LaSalle County Station, Units 1 and 2  
Facility Operating License Nos. NPF-11 and NPF-18  
NRC Docket Nos. 50-373 and 50-374

Subject: 2003 Annual Radiological Environmental Operating Report -  
Errata

Reference: Letter from George P. Barnes (EGC) to U. S. NRC, "2003  
Annual Radiological Environmental Operating Report," dated  
May 7, 2004

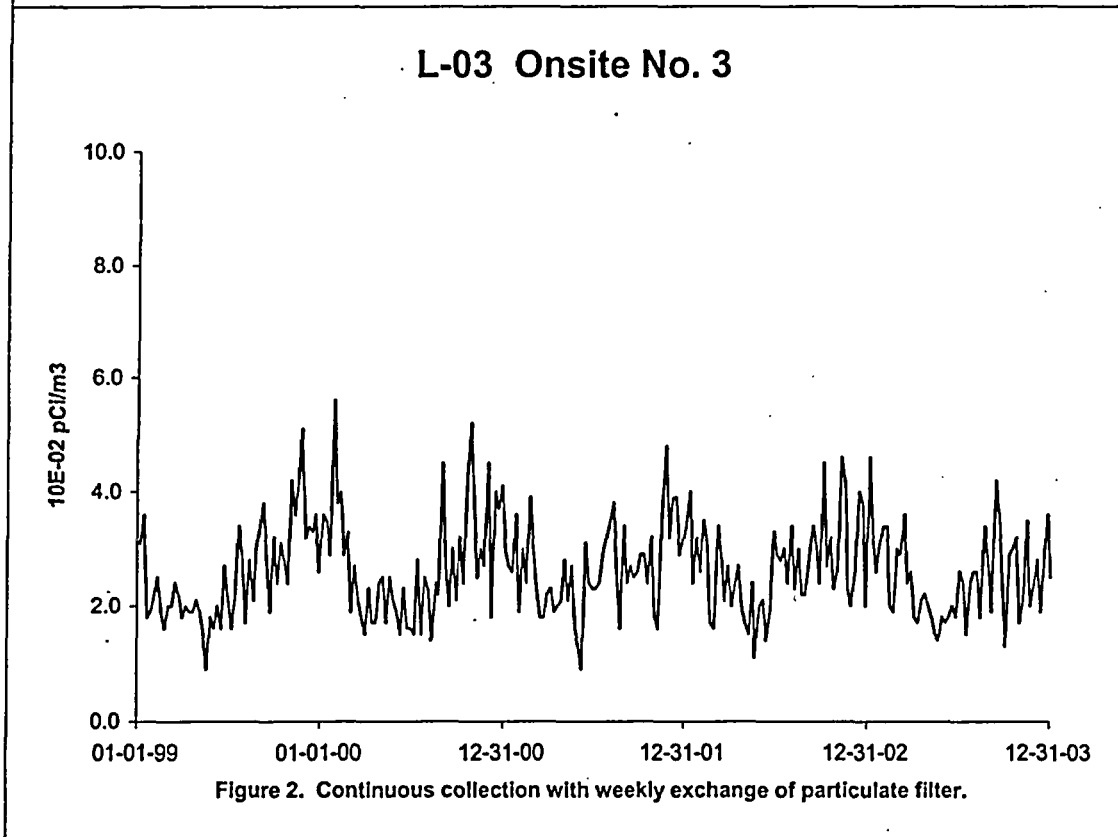
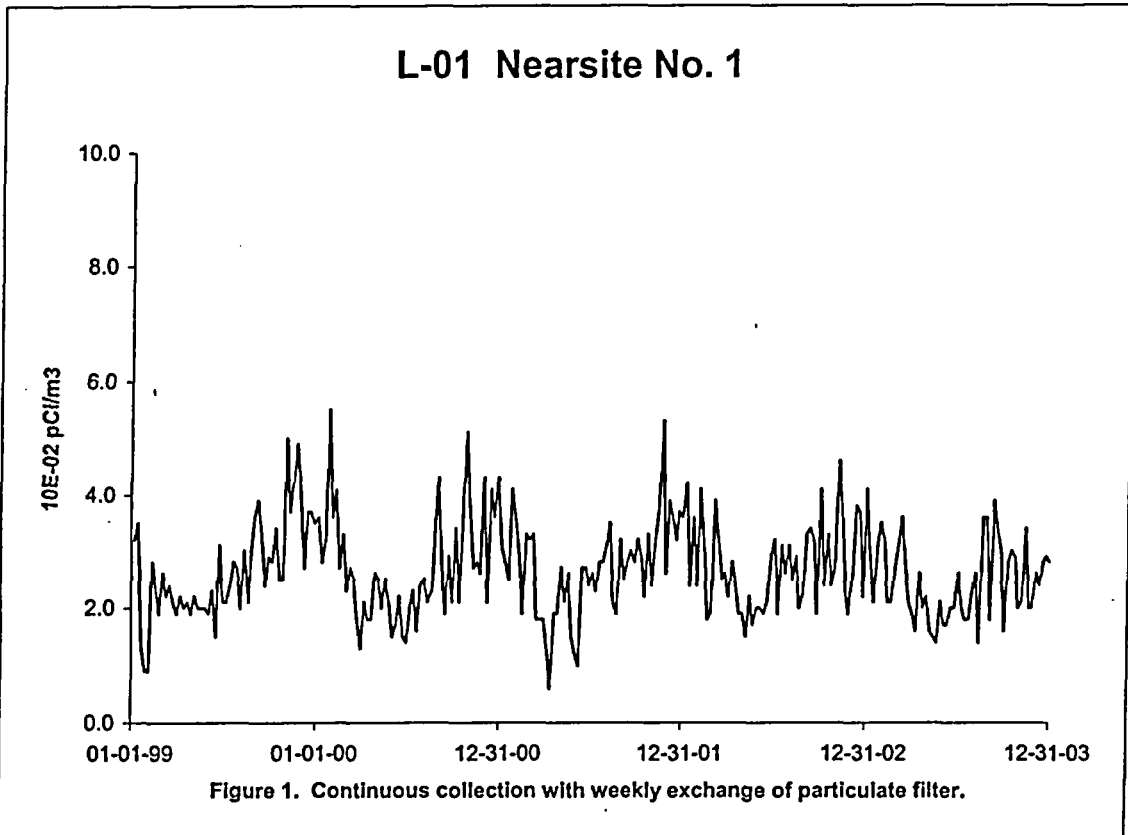
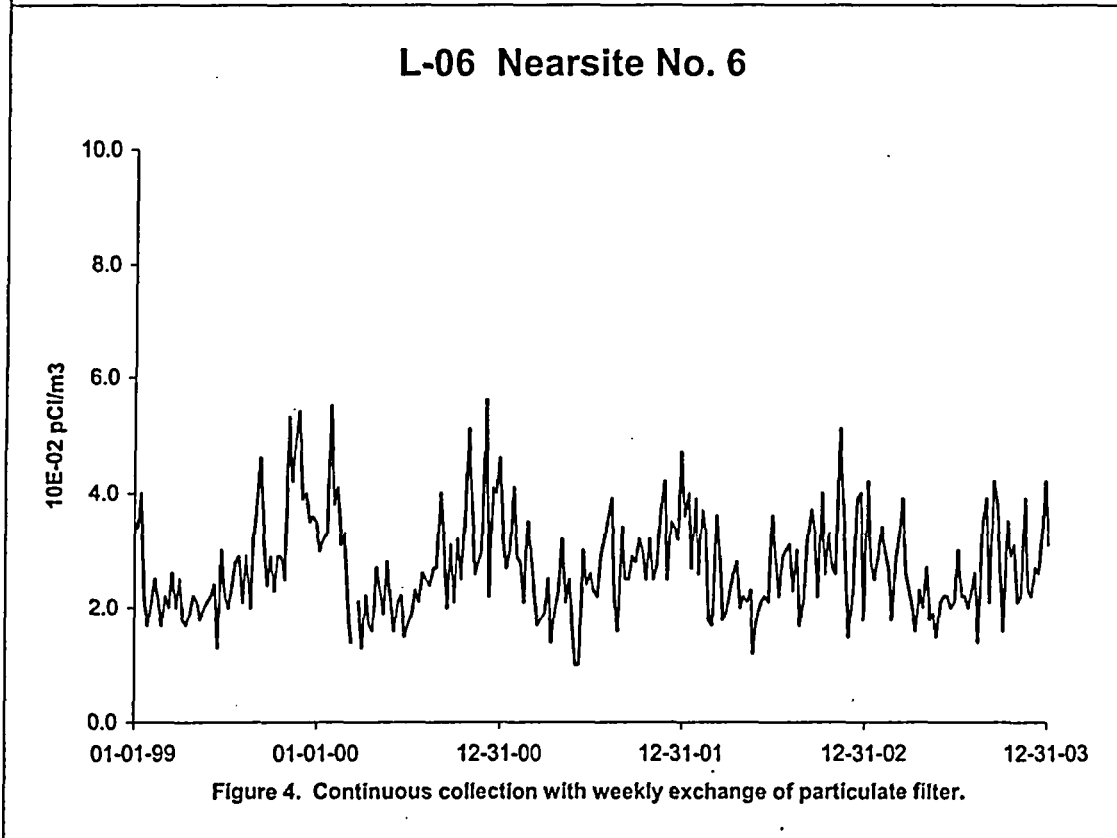
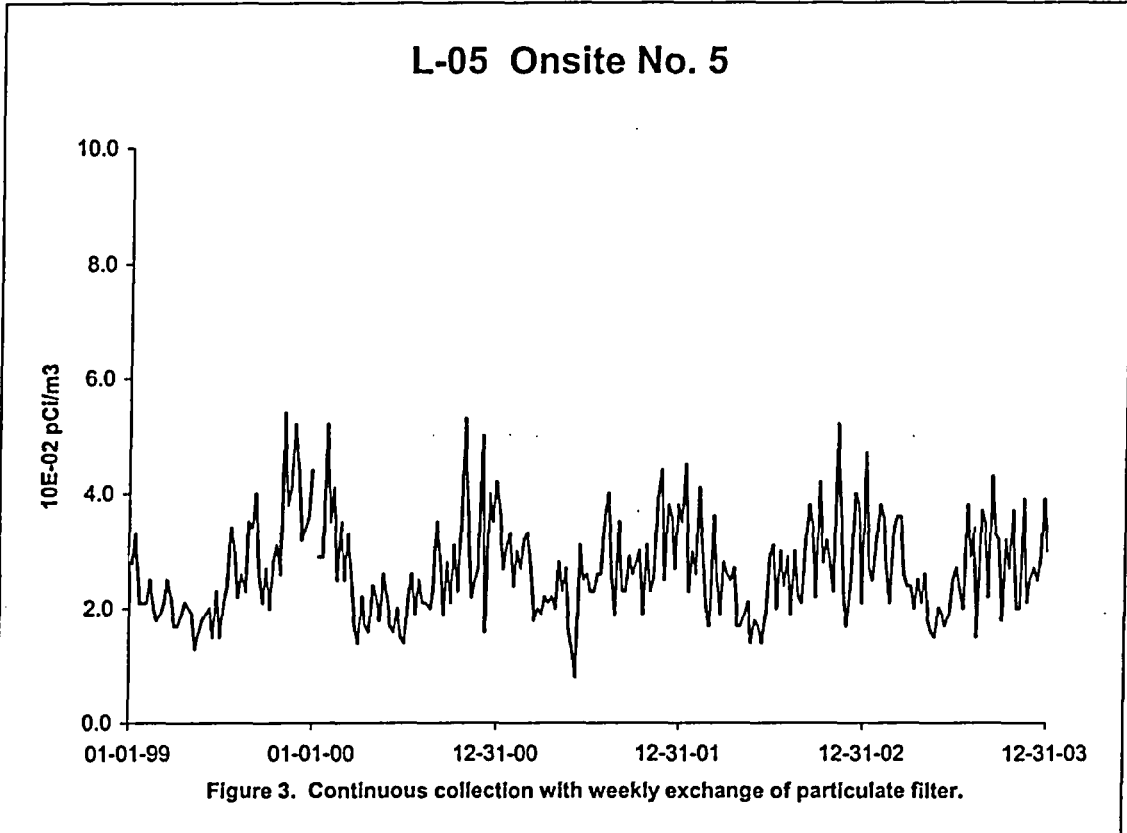
Enclosed are corrections to the referenced letter for Exelon Generation  
Company (EGC), LLC, LaSalle County Station. This transmittal contains  
corrections to figures 1 through 5 on pages III-41 through III-43. The original  
figures contained erroneous dates.
